IN THE DRAWINGS

REMARKS

(USSN 10/037,325)

Fig. 7

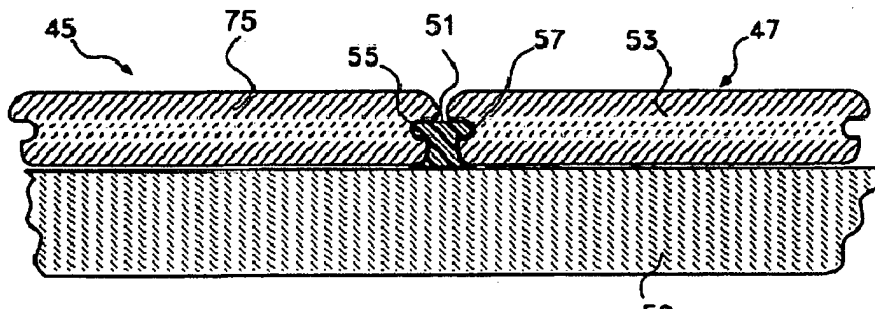
Please replace Sheet 2/2 of the existing drawings with a replacement sheet bearing amended Figure 7, as well as Figures 5-6, and 8, which are not presently amended. For the sake of clarity, Figure 7 is amended to change the cross-hatching of support board 59.

The Examiner has objected to the drawings entered on February 12, 2009, (i) disputing that Fig. 7 is an accurate cross-sectional view corresponding to what is shown in Figs. 1-3; and (ii) contending that it is unclear what material the cross-hatching of beams 45 and 47 represents, such that there is a question whether cross-sectional or end views are being shown.

As set forth by the specification, e.g. at page 31, line 14 to page 32, line 7, as amended, and with reference to amended FIG. 7, first and second horizontal beams (decking boards) 45 and 47 are secured to joist beam 59 using anchoring device 51. Horizontal beams 45, 47 are preferably composed of synthetic polymers, at least partially

For the sake of clarity, the specification has been amended in the Brief Description of the Drawings at pages 26-27 to clarify that Figs. 7 and 8 depict cross-sectional views. The Detailed Description of the Present Invention has been amended to further characterize Figs. 7 and 8. In particular, the paragraph beginning at page 31, line 14 has been amended to indicate that the cross-section presented in FIG. 7 is taken in a plane generally perpendicular to the long direction of horizontal beams (decking boards) 45 and 47 and generally parallel to the sides of joist beam 59. Accordingly, horizontal beams 45 and 47, joist beam 59, and anchoring device 51 are all depicted in cross-sectional view. Because beams 45 and 47 run generally perpendicular to joist 59 in a typical decking installation, the cross-section in Fig. 7 cuts beams 45 and 47 across end grain, while joist 59 is cut along side grain. Applicant respectfully notes that the terms “end grain” and “side grain” are understood with reference to decking systems in which the decking boards and joist are all made of ordinary wood. It is further noted that other materials are also suitable for the decking boards of the invention, e.g. materials selected from the group consisting of synthetic polymers, at least partially foamed synthetic polymer, wood, wood composite, and combinations thereof recited by

In view of the amendment of Fig. 7, the amendments of the specification, and the remarks set forth above, it is submitted that any lack of clarity of the drawings has been obviated, and that the drawings properly disclose all structural details essential for a proper understanding of the invention, when viewed in light of the specification as a whole.

(GB 1,350,754, as annotated by the Examiner)

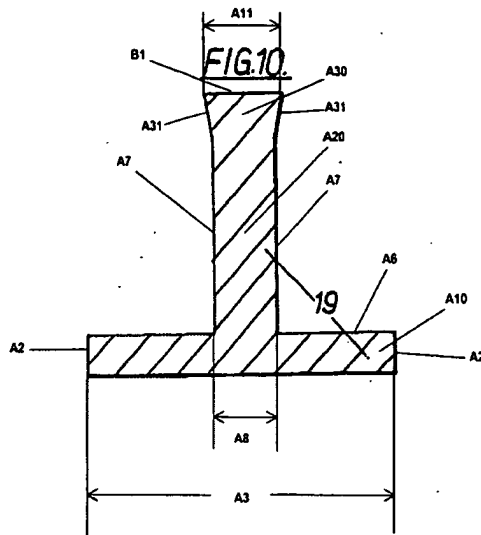
Regarding claim 29, the British patent discloses, in Figure 10, an anchoring device consisting essentially of a substantially flat horizontal top element A10, at least one substantially vertical support member A20, and a substantially flat horizontal bottom element A30. The top element A10 has a top view configuration including two sides A2 and a predetermined first width A3 as measured side to side. The first width A3 is measured at a maximum width between the sides A2. The top element A10 has an imaginary center line A4. The support member A20 is attached to an underside A6 of the top element A10 along the center line A4¹ and the support member A20 extends downwardly therefrom. The support member A20 has two sides A7 and a predetermined second width A8 as measured side to side at a maximum width. The bottom element A30 has a flat bottom view configuration, which includes sides A31 and having a generally trapezoidal shape, and a predetermined third width A11 as measured side to side at a maximum width at a trapezoidal base B1. The first width A3 is greater than the second width A8 and the third width A11. The third width A11 is greater than the second width A8. The device is made of molded plastic material (column 4, lines 72-84).

Applicant respectfully traverses the Examiner’s contention that the British patent discloses every structural feature of the anchoring device delineated by claim 29, as would be required for a proper rejection under 35 USC §102(b).

Applicant maintains that the foregoing functional limitations in fact positively recite further structural limitations that distinguish the anchoring device of claim 29 from any article disclosed or suggested by the British patent. There is no disclosure whatsoever in the British patent that "top"² element A10 is intended to be received into any groove of a tile or other article. To the contrary, the British patent universally teaches that element A10 is to be installed below the tiles and that the Fig. 10 strip is used with plain-edged tiles, whereas other configurations of grouting strips (e.g. strip 16 with interlocking, ear-like projections 16a) are to be used with grooved tiles. *See*, e.g., page 2, col. 1, lines 40-42 and Figs. 9-10; *compare* page 2, col. lines 28-32 and Figs. 4-6. Accordingly, applicant respectfully submits that a fair reading of the British patent contradicts the Examiner's proposition that width A8 of top element A10 is intended to be shaped and dimensioned so as to permit it to be received in a groove of any tile or other article. Significantly, Fig. 10, which the Examiner has cited, is said to be of a T-section strip appointed for use with a plain-edge tile, i.e., a tile lacking any edge groove or other like feature corresponding to the receiving slots delineated by claims 29 and 33. Page 2, col. 1, lines 11-13 and 40-43. Horizontal projections A2 of "top element" A10 are not received in any slot. Instead, element A10 is installed with its horizontal projection A2 underneath the back surface of each tile,

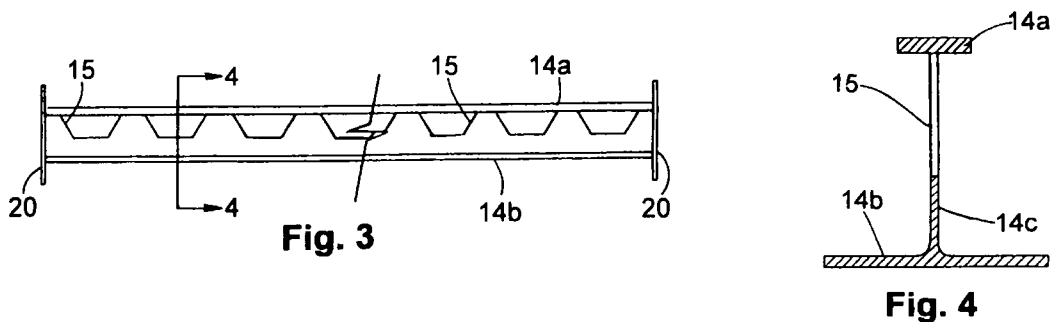
Regarding claim 29, Fisher et al. disclose, in Figure 3, an anchoring device comprising a substantially flat horizontal top element 14b, at least one substantially vertical support member 14c, and a substantially flat horizontal bottom element 14a. The top element 14b has a top view configuration including two sides A2 and a predetermined first width A3 as measured side to side. The first width A3 is measured at a maximum width between the sides A2. The top element 14b has an imaginary center line A4. The support member 14c is attached to an underside A6 of the top element 14b along the center line A4 and the support member 14c extends downwardly therefrom. The support member 14c has two sides A7 and a predetermined second width A8 as measured side to side at a maximum width. The bottom element 14a has a flat bottom view configuration which includes sides A10 and having a generally trapezoidal shape, and a predetermined third width A11 as measured side to side at a maximum width at a trapezoidal base B1. The first width A3 is greater than the second width A8 and the third width A11. The third width A11 is greater than the second width A8.

The present Office Action refers to the marked-up version of Fig. 3 of Fisher et al. included in a previous Office Action. Significantly, that version of Fig. 3 is depicted in an orientation that has been inverted with respect to Fig. 3 as it was originally presented in Fisher et al. The original orientation of Fig. 3 places the largest width of beam 14 (denoted as A3 by the Examiner) on the bottom, corresponding to its disposition in the finished construction shown in Figs. 1 and 2. By way of contrast, and without notice, the Examiner has placed the largest width (i.e. the width of flange 14b) on the top of the altered drawing. Applicant maintains that "top" and "bottom" as used in both Fisher et al. and the instant specification are terms of ordinary language. They have not been imbued with any special technical meaning by applicant or by any of the prior art references applied, including Fisher et al. It is submitted that the Examiner's alteration is repugnant to ordinary meaning and thus impermissible, absent clear evidence to substantiate the change.

Applicant particularly traverses the Examiner's assertion that "The terms 'top' and 'bottom' are merely relative terms." (Office Action at 16.) The distinction between "top" and "bottom" is not a matter of mere semantics, because the "bottom" of Fisher et al.'s dissymmetric structural steel beam 14 is defined by the direction of gravity and the beam's function of supporting planks 12a, 12b. Likewise, the "top" and "bottom" of applicant's anchoring device are distinguished by manner in which decks are installed, with decking boards on "top" of support boards. The Examiner has repeatedly referred to Fig. 3 of Fisher et al., which he has modified by presenting it

inverted from its original orientation, without acknowledgment. Applicant respectfully maintains that were the figure correctly presented, the lack of motivation to carry out the reconstruction required to obtain applicant's device would be readily apparent, because "top" and "bottom" indeed matter if the modification would require re-dimensioning both portions so as to properly carry out applicant's anchoring function.

(Chen et al., US Patent 6,363,677, as annotated by the Examiner)

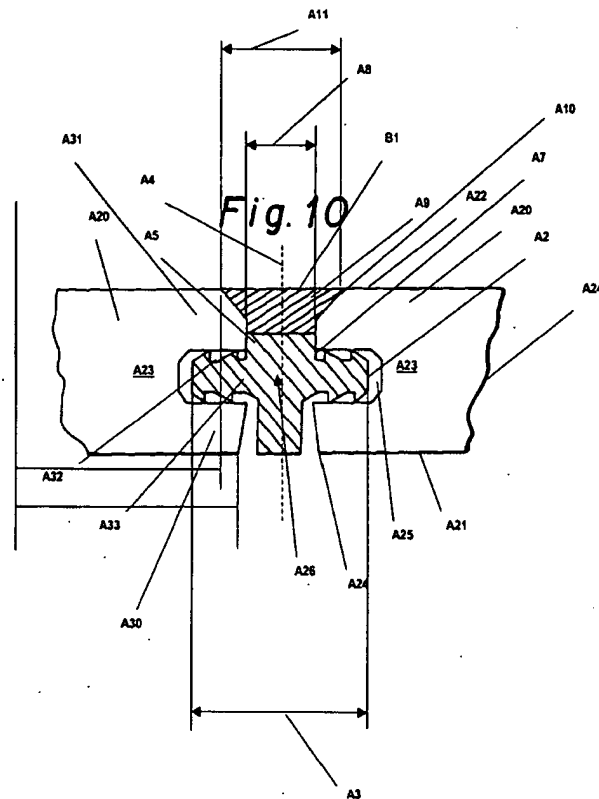
Regarding claim 33, Chen discloses in Figure 5³, a decking system comprising boards A20 and an anchoring device A26. Each of the boards A20 has a top A21, a bottom A22, two sides A23 and two ends A24. At least one groove A25 is located along one of the sides A23. The anchoring device A26 consists essentially of a substantially flat horizontal top element A1,⁴ at least one substantially vertical support member A5, and a substantially flat horizontal bottom element A9. The top element A1 has a top view configuration including two sides A2 and a predetermined first width A3 as measured side to side. The first width A3 is measured at a maximum width between the sides A2. The top element A1 has an imaginary center line A4. The support member A5 is attached to an underside A6 of the top element A1 along the center line A4 and the support member A5 extends downwardly therefrom. The support member A5 has two sides A7 and a predetermined second width A8 as measured side to side at a maximum width. The bottom element A9 has a flat bottom view configuration, which includes sides A10, and having a generally trapezoidal shape, and a predetermined third

Applicant respectfully traverses the Examiner's contention that the combination of Chen et al. and Livezey discloses or suggests the decking system delineated by claim 33. Applicant acknowledges, as a general proposition, that decking systems involving decking boards situated atop support boards are conventional. However, any such knowledge falls far short of providing the anchoring device required by applicant's claims. Whether taken singly or collectively, Chen et al. and Livezey clearly fail to disclose or suggest applicant's anchoring device. Rather, the device provided by Chen et al. is clearly distinguished structurally from applicant's form, and there is no suggestion that any structure of Chen et al. should be reconstructed extensively, as required to reach applicant's subject matter, or that a skilled person would have any reasonable expectation of success in carrying out such a modification.

The confusion arising from the Examiner's inversion of the supposed Chen anchoring device is even further compounded by the Examiner's characterization of the sides A2 as defining a width A3 of what he purports to be the top element A1 [*sic*]. On the other hand, claim 33 calls for an anchoring device having a "substantially flat horizontal top element having a top view configuration which includes two sides..." (emphasis added). Applicant respectfully submits that the allegedly anticipatory structure does not have the substantially flat horizontal top view configuration delineated by claim 33. Instead, the portion of element 54 that extends downward from the projections received in board grooves A25 in the depiction of annotated Fig. 10 (the "top" of the Chen et al. structure as apparently understood by the Examiner⁵) precludes the Examiner's conclusion, because it establishes a surface of element "A1" that is not substantially flat horizontally.
